Date: September 27, 2010
Refer To: ENV-RCRA-10-181
LAUR: 10-06430

SUBJECT: TA-50 RADIOACTIVE LIQUID WASTE TREATMENT FACILITY, DISCHARGE PLAN (DP-1132), MINOR MODIFICATION

**ENCLOSURE 1**

1000 GAL. TANK PARTIAL PIPING - ISOMETRIC  
SCALE: NONE

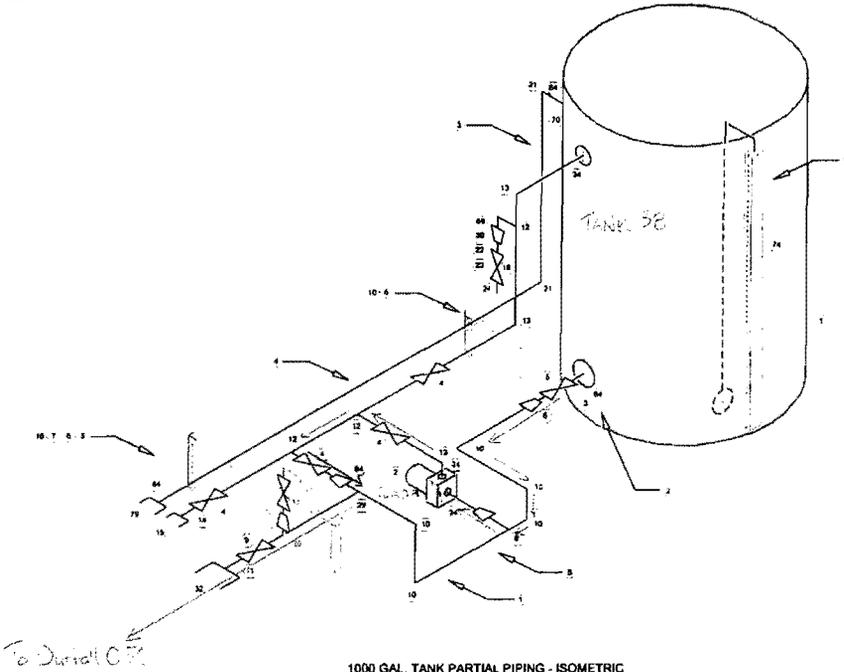
will be in Room 38, on the discharge side of the pump that will pump the Tank 38 contents to the outfall. Enclosure 1 shows an isometric drawing of Tank 38, associated piping, recirculation/discharge pump, proposed NPDES sampling location and flow paths during discharge to Outfall 051. If discharges to Outfall 051 are made from the Frac tanks, the presently approved NPDES compliance sampling location in Room 116 at the RLWTF will continue to be used.
